APPENDIX A
Comment Letters

DRAFT MITIGATED NEGATIVE DECLARATION (ND) FOR KIMBALL SUBSTATION
PROJECT (SCH# 2009041042)

California Pubic Utilities Commission’s Mitigated Negative Declaration for the Southern California Edison’s Kimball Substation Project: SCH# 2009041042

RE: 2009 Draft MND for the Kimball Substation

Area Plan
 Figure 16

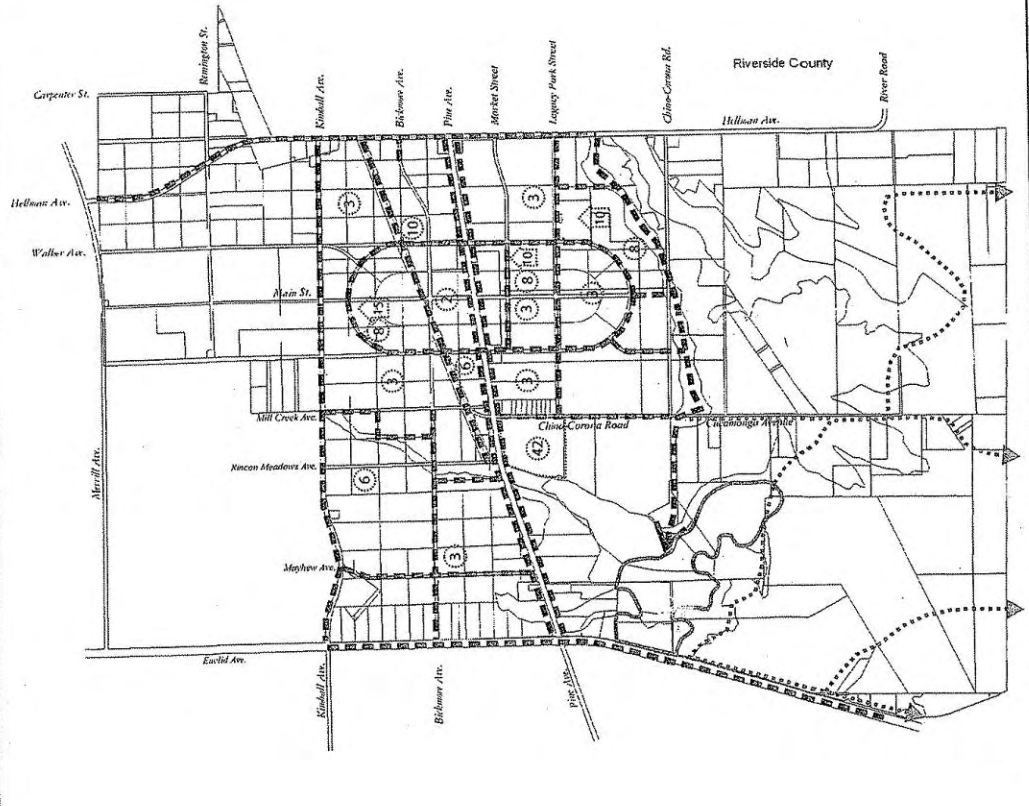
1. The study indicates that the "subtransmission line modification alignment" (Segment 10) south of Pine Avenue will result in a second circuit being placed within an existing right-of-way within The Preserve Specific Plan. This right-of way is within the future Community Core (Downtown), near a proposed school site, and residential land use designations. The Community Core is planned to be a highly urbanized area of commercial and residential land uses (refer to attached Figure 16 of The Preserve Specific Plan).

The poles and conductor on Segment 10 do not align with future planned roadways, which suggest the proposed lines may be placed in close proximity to future commercial and residential land uses resulting in the easement sharing a lot line with a residential property/lot.
